RIVERBEND CROSSING FILING NO. 1

STREET IMPROVEMENT, STORM SEWER, AND SIGNAGE & STRIPING CONSTRUCTION DRAWINGS

EL PASO COUNTY, COLORADO

PCD FILE #: SF1844

SOUTHMOOR DRIVE WIDENING DETAIL - URBAN NON-RESIDENTIAL COLLECTOR
SCALE: N.T.S.

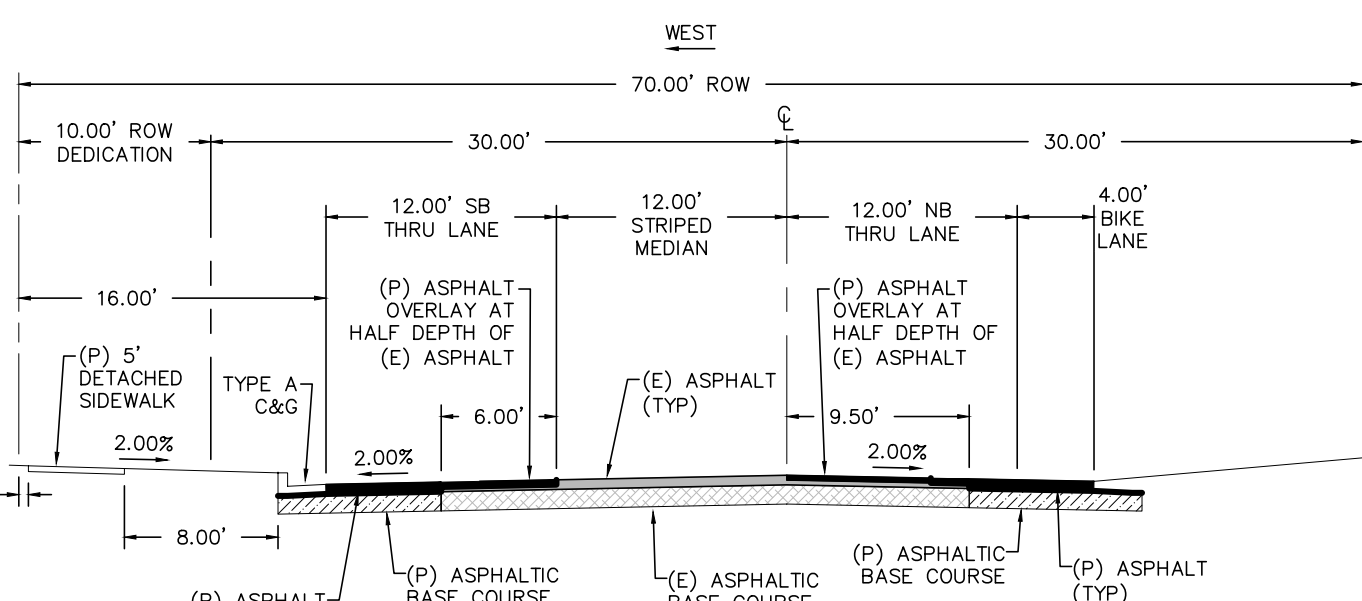
add "Filed in accordance with the requirements of the El Paso County Land Development Code, Drainage Criteria Manual Volumes 1 and 2, and Engineering Criteria Manual, as amended."

Figure SB-2
Outlet Sizing
Application Techniques and Maintenance
Requirements

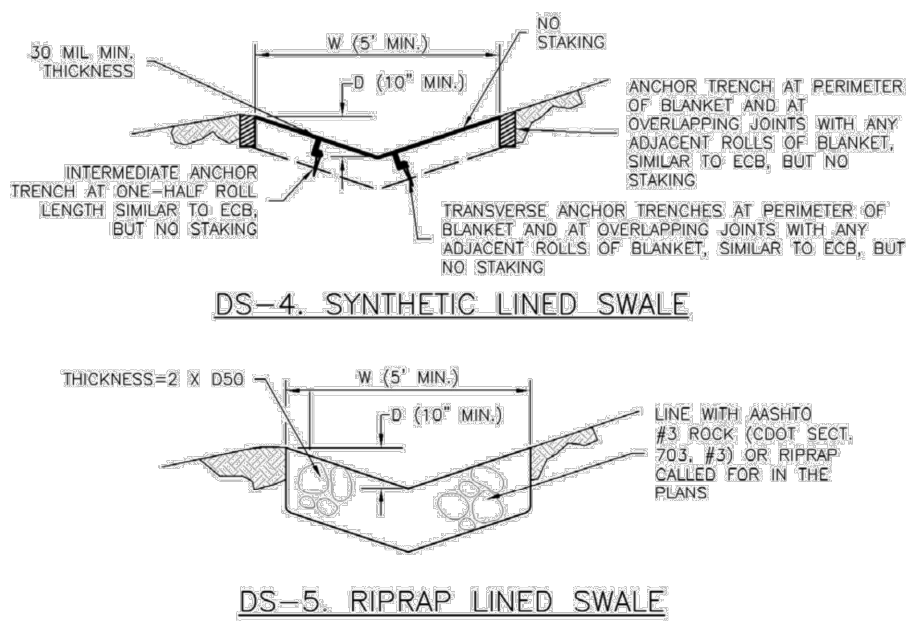
Provide details of temporary sediment basin, including riser pipe perforation sizing, number of rows, required volume, and tributary area to the sediment basin. (highlight sizing in tables SB-1 and SB-2 above.)
